Bureau of Alcohol, Tobacco,  
Firearms and Explosives

*Firearms Technology Industry Services Branch*

907010:MCP  
3311/304296

This refers to your correspondence to the Bureau of Alcohol, Tobacco, Firearms and Explosives (ATF), Firearms Technology Industry Services Branch (FTISB), which accompanied your submitted sample of an "Adjustable Pistol Stabilizing Brace" mounted on a semiautomatic pistol. Specifically, you asked whether the subject device could be lawfully installed on a handgun.

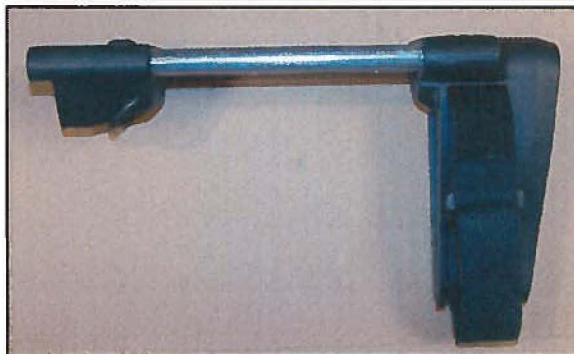
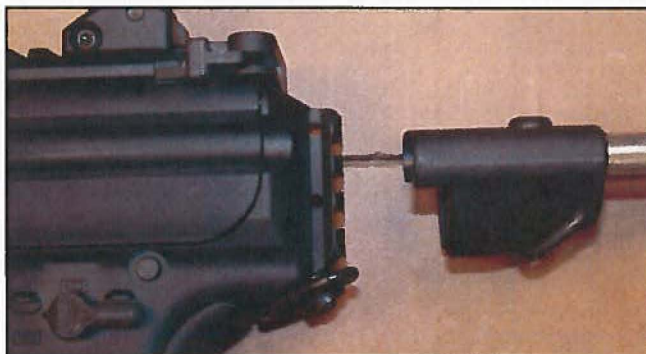
Further, the submitted brace contains a series of raised ridges at its rear (see photo below):

The subject ridges on the rear of the submitted sample serve no functional purpose in the design of a pistol brace; however, the ridges do provide a non-slip, gripping surface, a feature commonly associated with butt stocks/shoulder stocks as well as firearms designed and intended to be fired from the shoulder. You indicate production models will not have this raised surface so as to preclude its usefulness to be shouldered.

Your submission would therefore be approved for use on handguns similar to that attached to your submission, provided there are no raised ridges on the rear of the brace. Its use on smaller, or more conventional handguns, would not be authorized because the purported intent and design offers no benefit for small handguns.

In closing, FTISB finds that the submitted sample is approved for use as a pistol stabilizing brace provided the raised ridges are removed from the rear of the device and not added at a later time.
